**Errata: CS4341 Rev. B****CS4341 24-Bit, 96 kHz Stereo DAC with Volume Control**

All references to the CS4341 mentioned below shall be taken to refer to revision B of the CS4341 product. The hardware revision code can be found in the 10 character field printed below the part number on each chip. The letter which appears as the fifth character from the right is the revision code (e.g. ZNAXYB9846 is a Revision B part).

Figure 1. I<sup>2</sup>C SCL Buffer Example

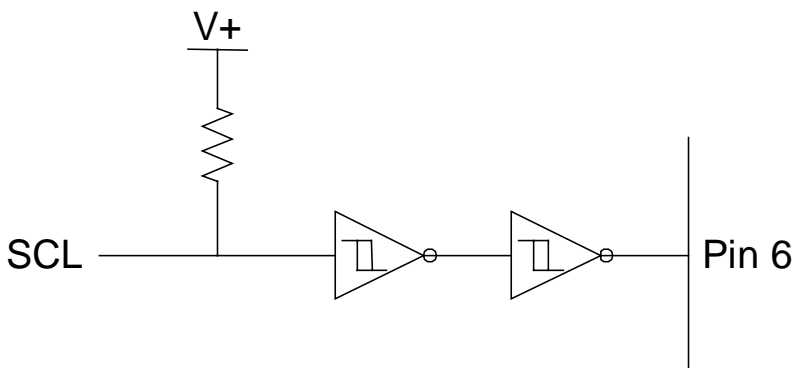
Pin 6 (SCL/CCLK) of the CS4341 does not have sufficient hysteresis to meet the data sheet rise time specifications. The I<sup>2</sup>C rise time  $t_r$  and the SPI rise time  $t_{r2}$  must be less than 30 ns for proper operation. This prevents the use of standard I<sup>2</sup>C configurations with a resistor pull-up. This problem can be worked around by placing a Schmitt Trigger buffer, for example a 74HC14, on the SCL line just prior to the CS4341. This will not affect the operation of the I<sup>2</sup>C bus as pin 6 is an input only.
